City of Portland  
**Bureau of Development Services**  
Land Use Services Division

## MEMORANDUM

**Date:** October 20, 2008  
**To:** Kurt Schultz, Sera Architects  
**From:** Noelle Elliott, Development Review  
Phone number 503-823-7812  
**Re:** 08-136009 DA – Wyndham Hotel at NW 14<sup>th</sup> Ave & NW Irving St  
Design Advice Request Summary Memo for October 2, 2008

This memo summarizes **Design Commission** design direction provided at the October 2, 2008 DAR.

*East Elevation  
 (facing NW 14th Ave)  
 EA 08-136009 DAR  
 2nd DAR hearing*

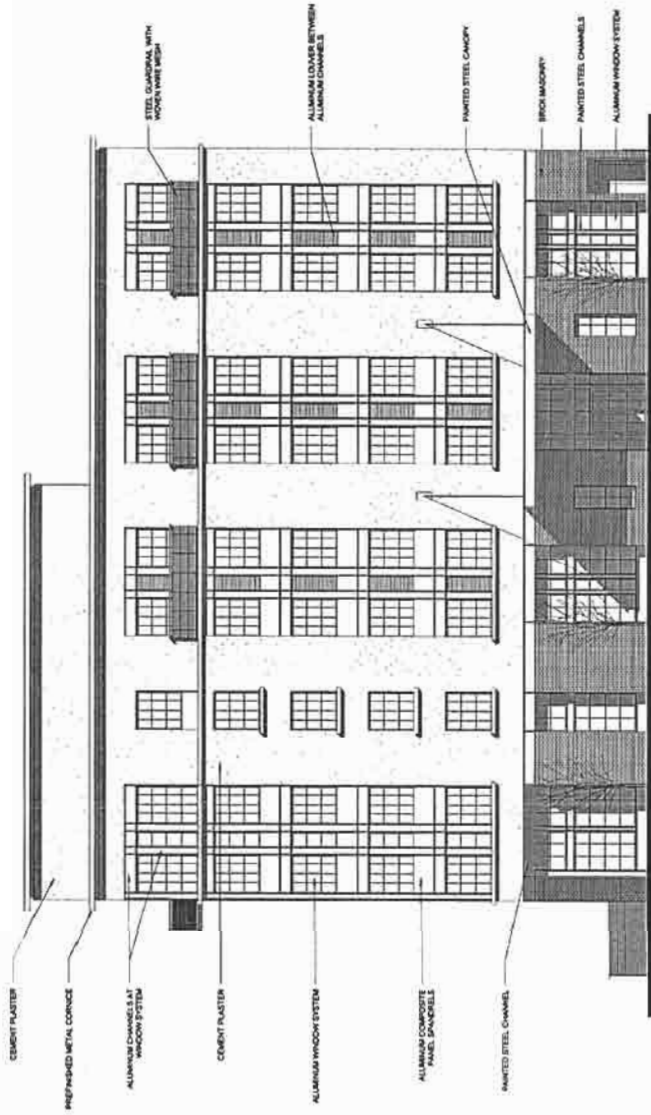
- The real-estate office will kill the corner at 14<sup>th</sup> and Irving because of its lack of significant activity and interactivity with the neighborhood.

*South Elevation  
(facing Irving Pedestrian Pathway)*

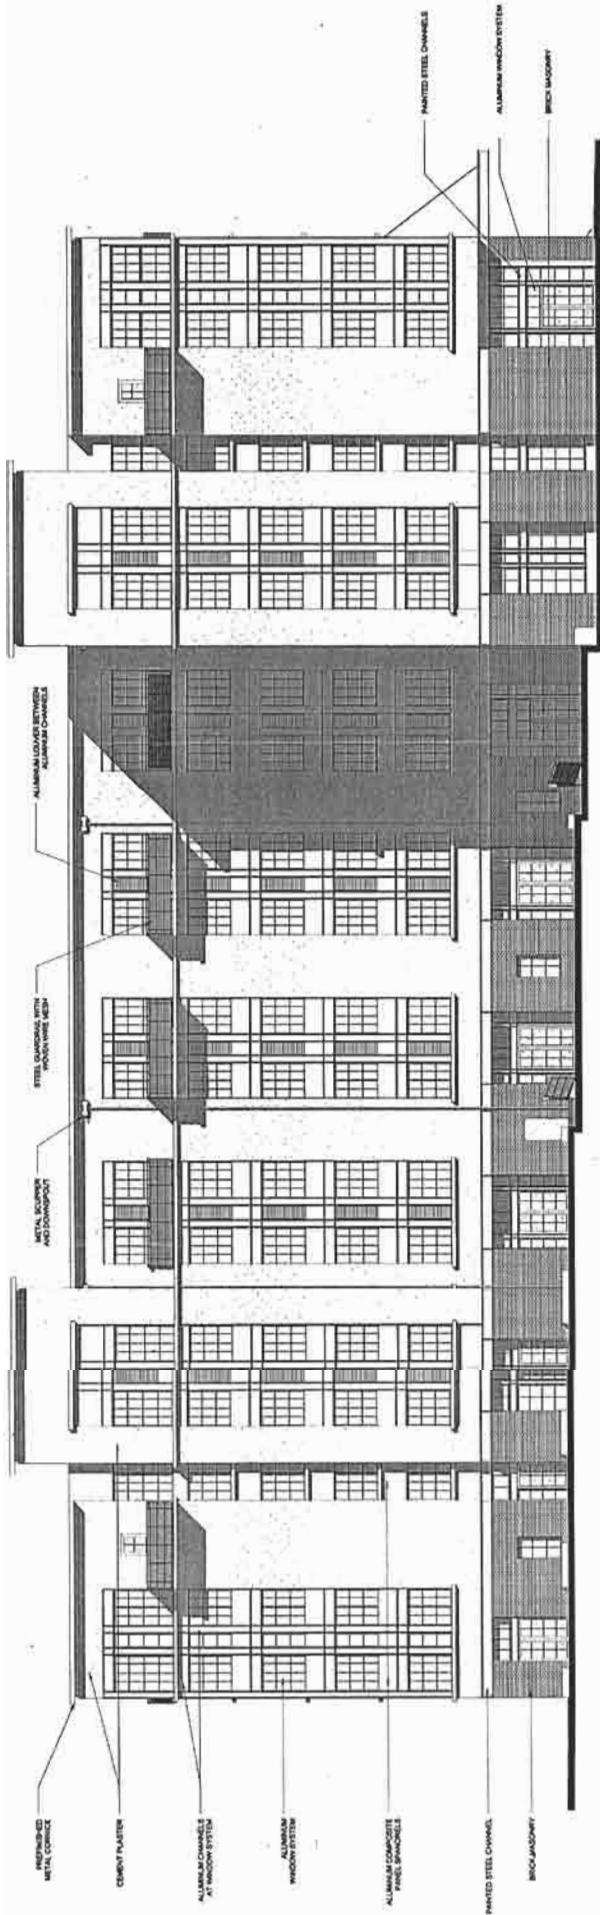
- The building has a 20,000 SF footprint, with 400-ft of street frontage, and effectively (as it relates to the activity on the sidewalk), 250 ft of that frontage is dead to the world. This program has been dropped onto this site and is not relating to its context. Guidelines A8, B5, and C9 are not being met – at least 250 ft of the building in the current condition will never meet those standards and is not approvable. The design doesn't meet the spirit of the standards; it is not activating the corner or the pedestrian way.

- Consider filling in the light-well (courtyard) at ground level with commercial, outward focused program at the ground floor. You have the opportunity to become part of the Pearl District community and to address the public environment. The pedestrian walkway is an incredible public amenity that you are orienting units towards, but you're not giving anything back to the public space. It is segregated from the Pearl District. Your current design is doing a good job at excluding the public and separating the hotel from the Pearl District.

- The current program at the ground floor will likely never inject healthy activity into the pedestrian pathway. The location of the private amenities at the ground level hurt the public environment and the amenities themselves. The private amenity spaces in the courtyard are programmatically misplaced in the building; the hot tub doesn't belong in the courtyard or at the edge of a public pathway. The frontages of buildings within the Pearl District are regarded as part of the public realm. The private programs of this building should be on an upper level. Until the program is worked out, there will be significant problems with this proposal.

- You have two clear options, make a public courtyard, or make an active retail edge along Irving. If the courtyard stays, it should be a public garden courtyard, without a barrier, and the ground floor must incorporate substantial commercial space.

- The courtyard should be a public amenity, one that invites the public in and interfaces with the neighborhood – that is the spirit of Portland. The private courtyard suggests that guests want to look at, but not interact with the public. If you want the Pearl District to be your clients/community, then invite it in. Consider embracing the neighborhood, opening things up and allowing people to interact with the courtyard. It would be positive for the organization and the community if the design embraced the neighborhood. The Commission has made a very strong effort to open up courtyards in the Pearl District – there is an extensive history of this being met and working well. A private courtyard and a private ground floor effectively take the building off of the block as it relates to the pedestrian realm.

- The courtyard should feel public, and any sort of screening element should not be perceived as a separation. Consider incorporating amenities such as a planter for people to sit against, or a water feature along the pedestrian pathway. The existing screening is reading too much as a buffer. When you come back, there should be a clear sense of openness between the two spaces.

- The building is not creating a gateway at the ground floor, as you intend. Could there be a canopy at the ground floor on the Pedestrian way that marks the Commission's requested active "retail" corner? An awning at 14<sup>th</sup> and Irving would be helpful to provide a gesture that indicates that this is a pedestrian gateway. The unfixed seating at 14<sup>th</sup> & Irving, isn't successful. Fixed seating would be a nice gesture to the neighborhood. Art would be another nice addition to the corner.

*West Elevation  
 (facing NW 15th Ave)  
 EA 08-136009 DAR  
 2nd DAR hearing*

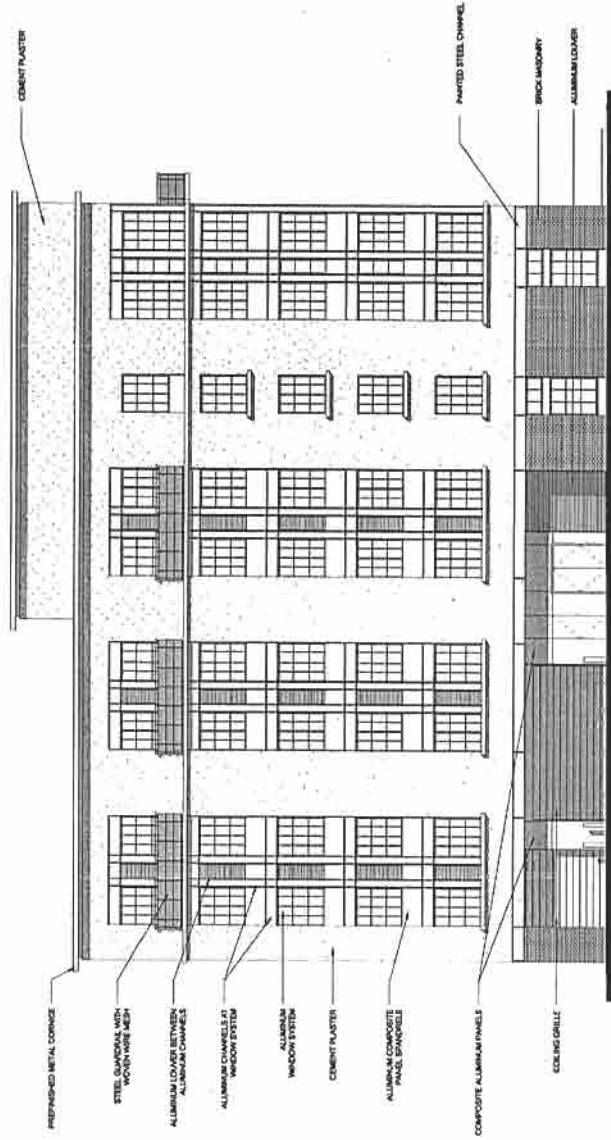
- The intention of active ground floor corners is not accomplished on 15<sup>th</sup> Ave.
- Consider a canopy at the loading area, which is what traditionally happened along 15<sup>th</sup> Ave loading docks.
- Making the doors glass would create a better sense of pedestrian safety and openness.
- In rethinking the ground floor, consider commercial space or something more active happening on 15<sup>th</sup> Ave. Consider tucking a restaurant or commercial space into the 15<sup>th</sup> Ave façade, it might be a very dynamic location for a little restaurant.
- Bikes on 15<sup>th</sup> Ave might work well.
- A more flush approach to vehicular entrances on 15<sup>th</sup> Ave might be an improvement. Setting them back creates too much shadow.
